SUBJECT: METHOD OF ANCHORING
TANK IN GROUND

In regard to the application for a permit to install a 2000 gallon underground storage tank and an electric pump in connection therewith at the above named location, we have a memorandum from the Fire Chief outlining the conditions under which he will be able to approve the installation. He writes as follows:-

Examination of plan with application for permit for construction of a one story wood frame boat shed 24 feet by 50 feet at the above named location discloses the following variances from and questions as to compliance with Zoning Ordinance and Building Code requirements.

AP 501 Danforth St.—Proposed roof sign for Gulf Oil Corp., designed and manufactured by Colonial Neon Northern Inc. and to be erected by United Neon Display

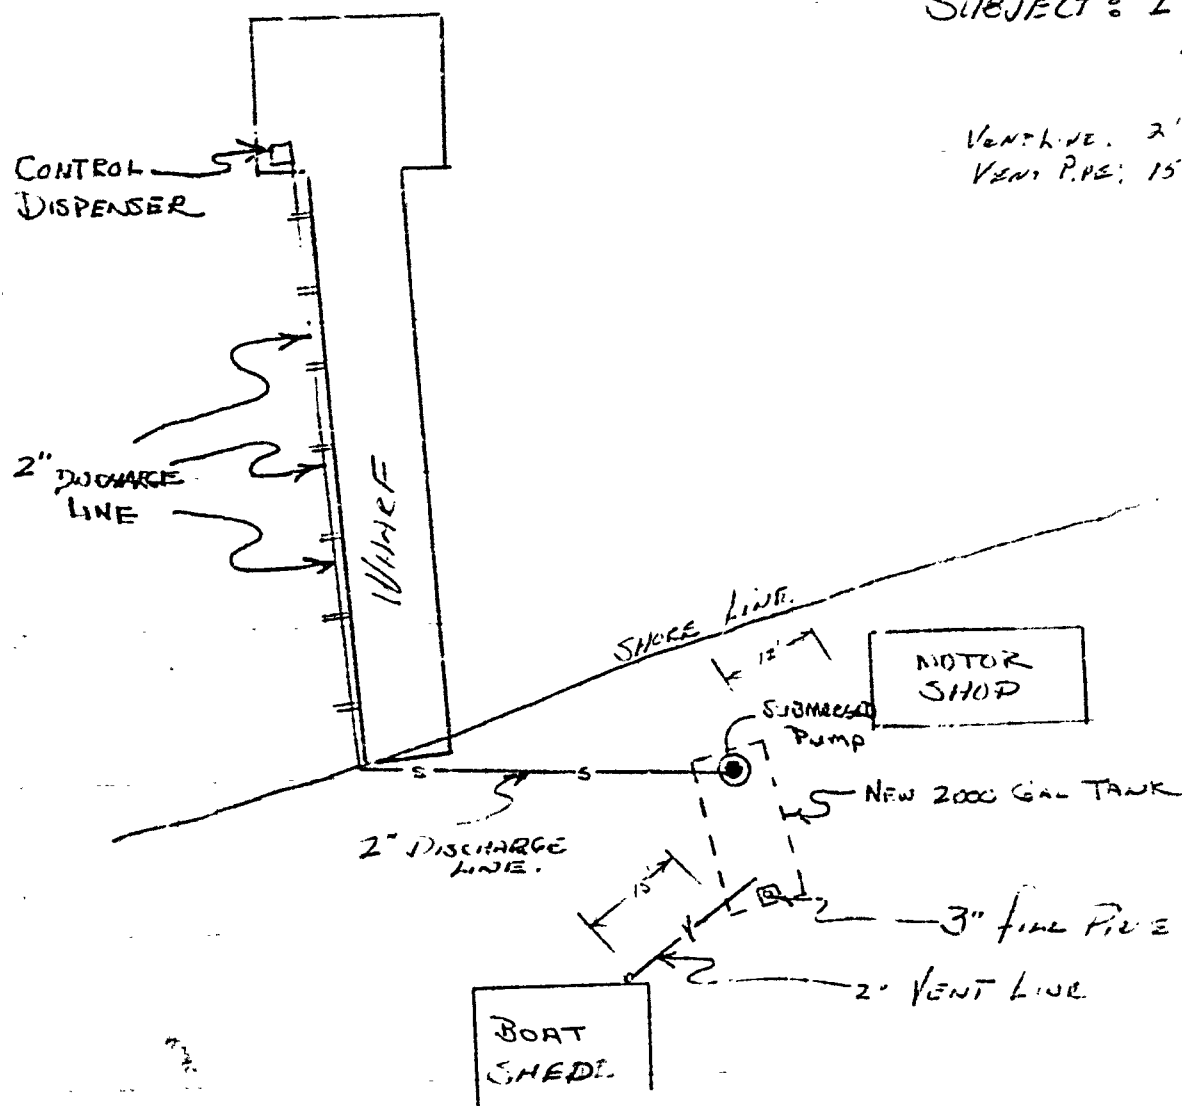
1. Detailed plans must be shown whereby this tank will be kept from "floating" in case it should be empty or nearly so in extreme high tides or other flood conditions.

2. Also to be considered is the piping and pump installation. Piping between shore and wharves of timber construction shall be provided with swing joints or other approved means to permit the movement of the pier or wharf and shore piping without any strain on the pipe lines. Pipe line control valves shall be so marked as to designate their use.
